**Supplement to Product Change Notification PCN-2016-02-17**

28.06.2018

**Old version****New version**

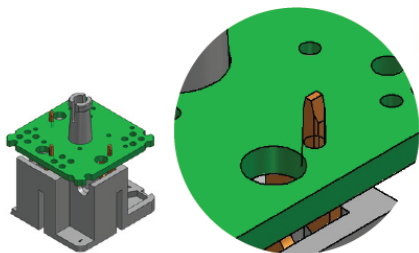
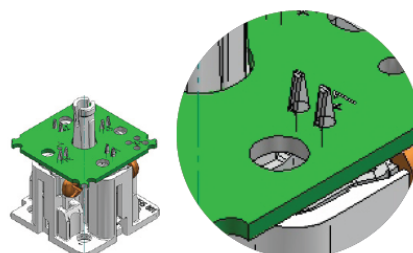
**PCB Technology, Contacting (double PressFit) and Protective Circuitry**

In order to match the latest PCB technology for all our circuits, Belden redesigned the PCB-assembling and the connection to the contact-bearer. To guarantee a better vibration-behavior and reliability of contact resistance and joints, the design has been up-graded to a double PressFit connection.

**GDML 2016 LED 24 GB black or grey as well as GDML 2011 LED 24 GB black or grey**

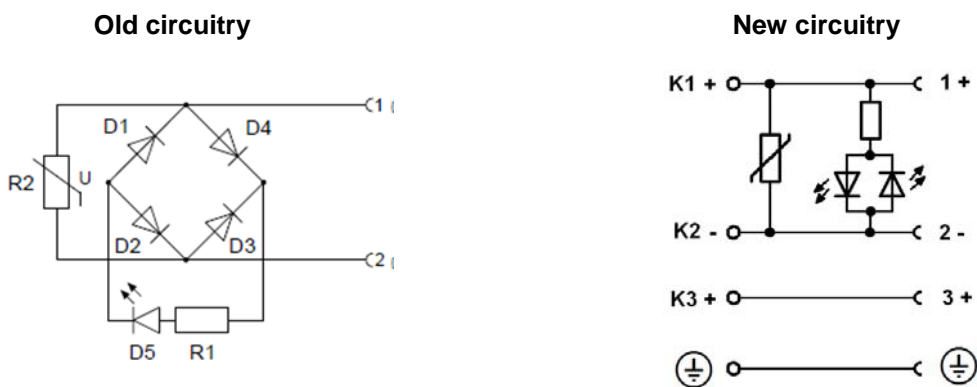
In the course of the PCB improvement defined protection circuitries were modified as well. So far bridge rectifiers and blocking diodes were used in combination with light-emitting diodes (LED) to ensure the functionality of the LED also with alternating current. At the same time reverse polarity protection was ensured with an antiparallel diode. In the scope of PCN-2016-02-17 the previous monopolar LEDs were replaced by bipolar LED versions, which can be operated with direct as well as with alternating current. A prior rectification is thus no longer necessary. Also, with the bipolar light-emitting diodes the risk of polarity reversal is no longer given as they enable a flexible connection. Due to the replacement of former monopolar LEDs by bipolar light-emitting diodes the following new circuit diagrams emerge:
